**CAMDEN FAMILY HEALTH  
WEBSTER COUNTY, WEST VIRGINIA  
CAMDEN FAMILY HEALTH CONFERENCE ROOM ADDITION**

**ADDENDUM #2  
May 22, 2025**

**THRASHER PROJECT #T60-11030**

**1** CONFERENCE ROOM FLOOR PLAN - ELECTRICAL  
 E3.01 1/4" = 1'-0"

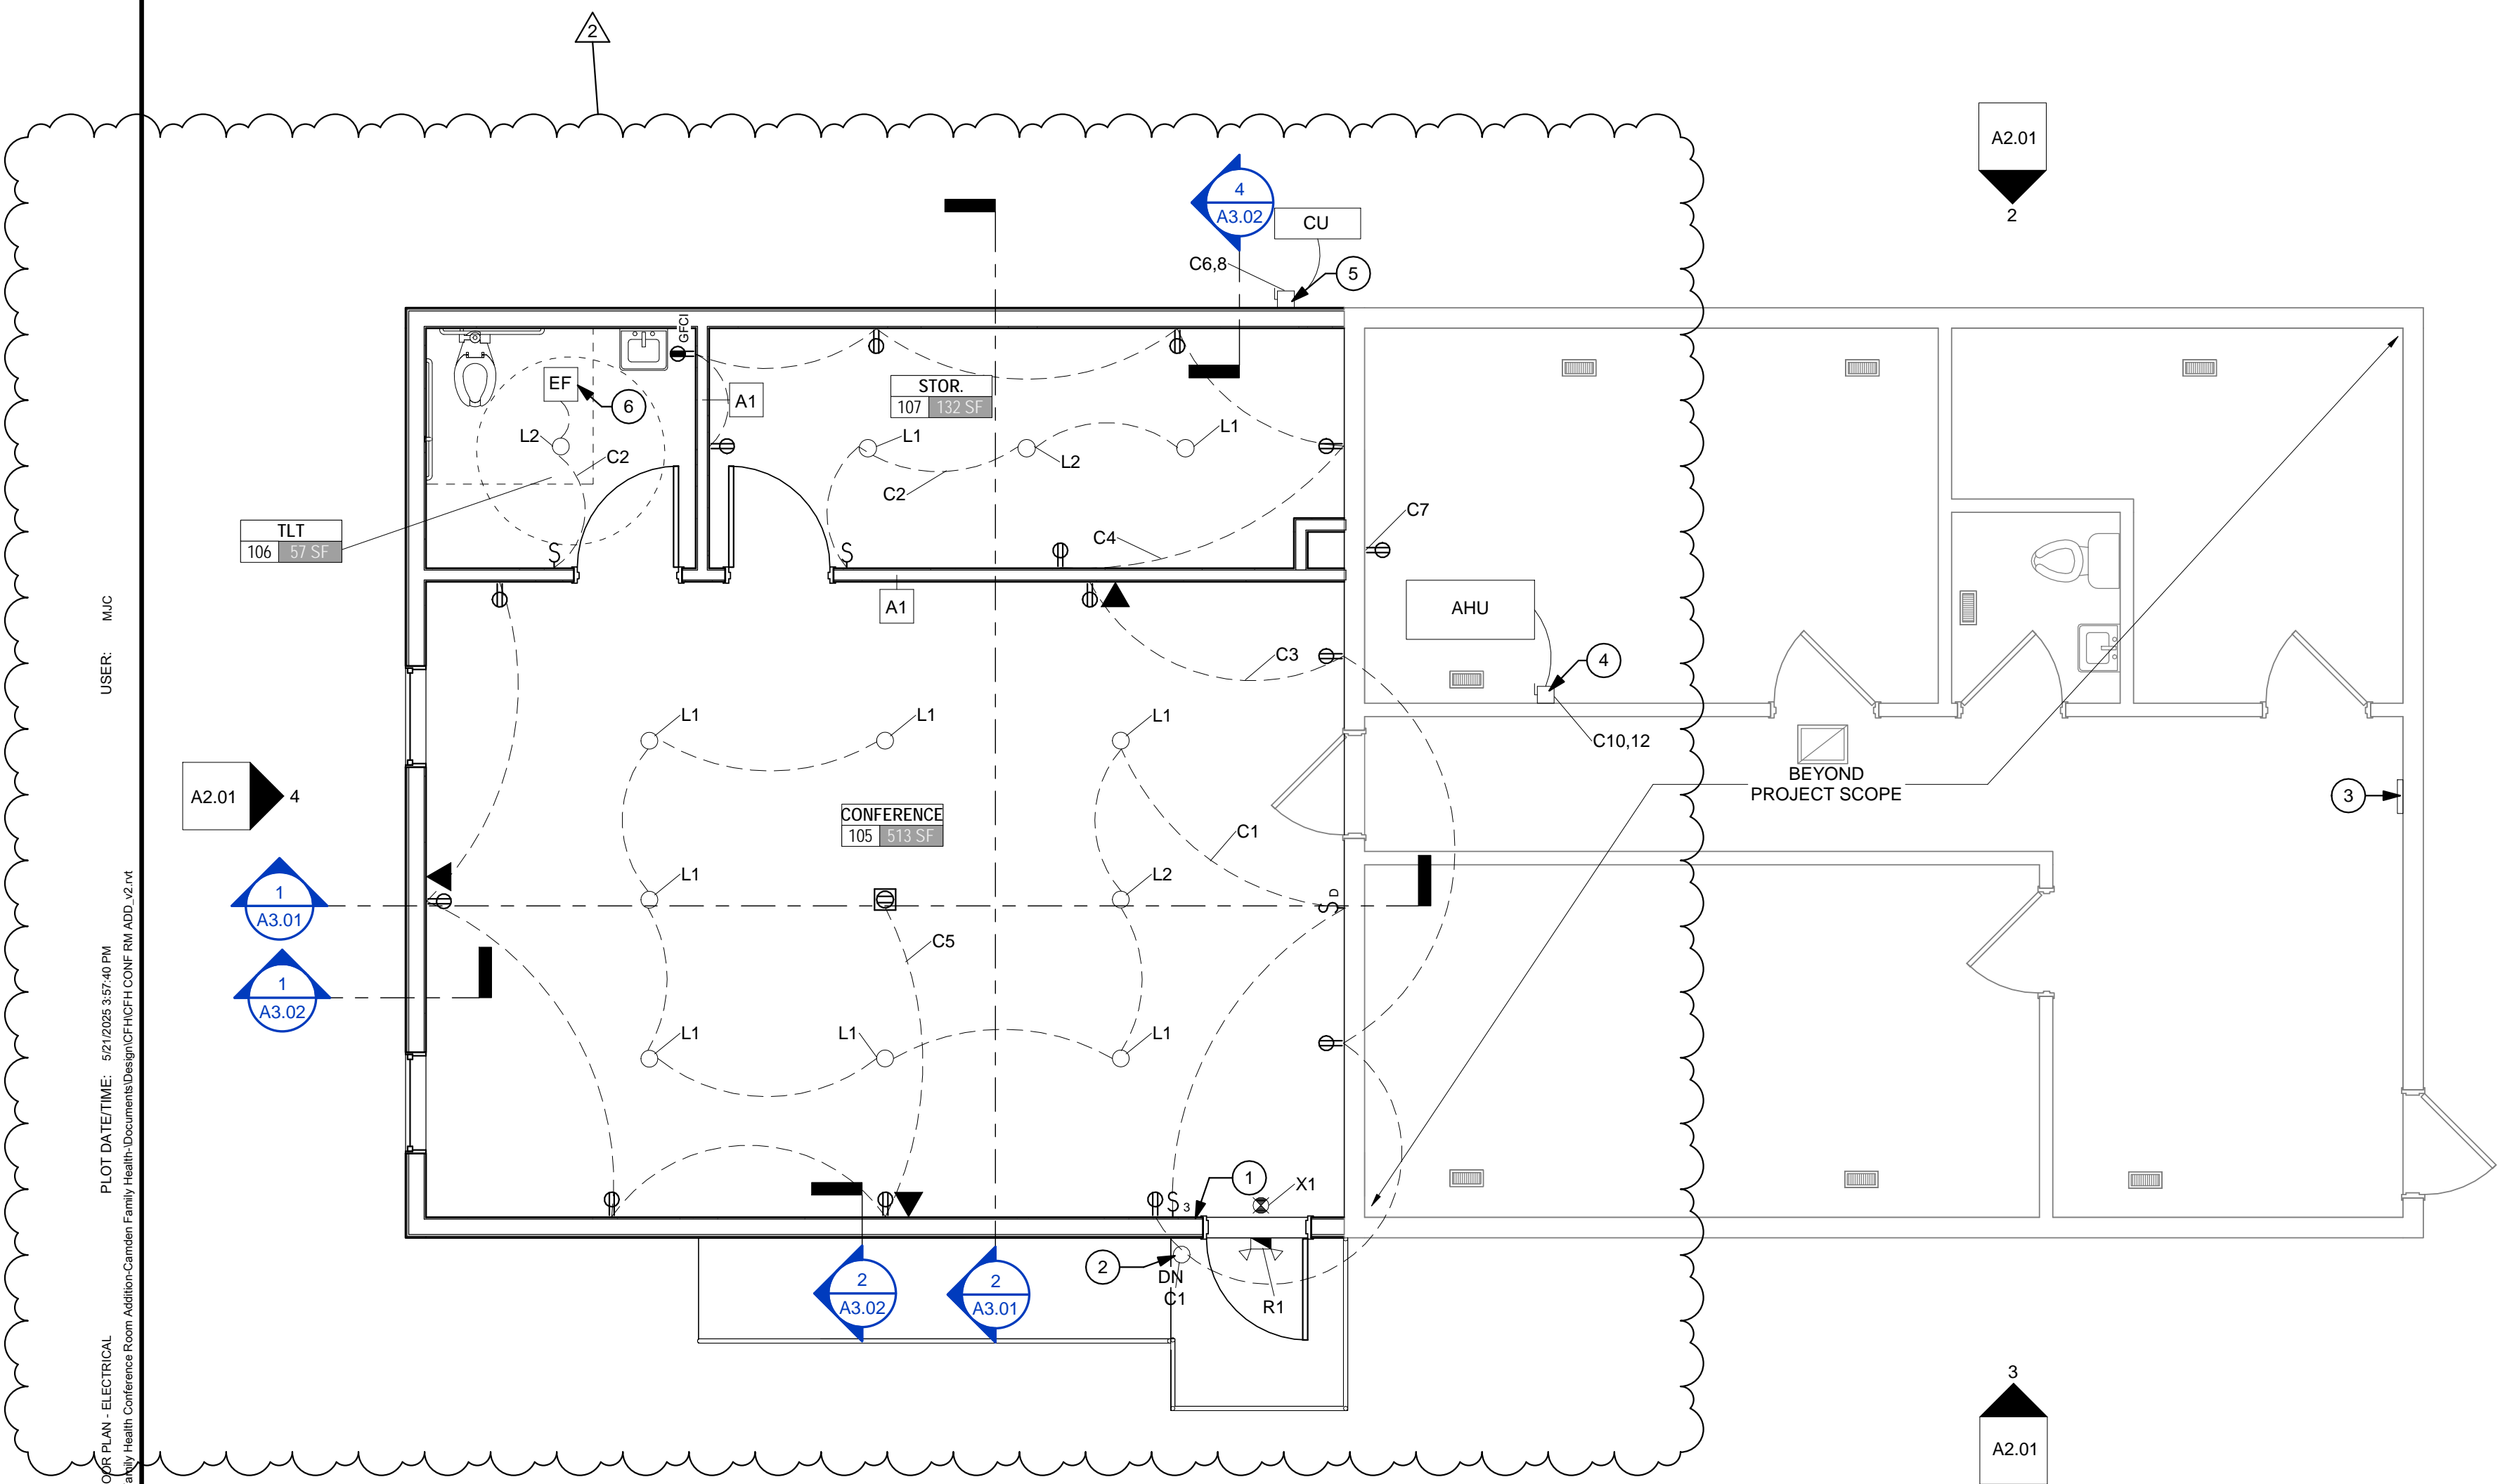
Is there a light fixture schedule available for the project?

See sheets E1.01 and E3.01 included in this addendum.
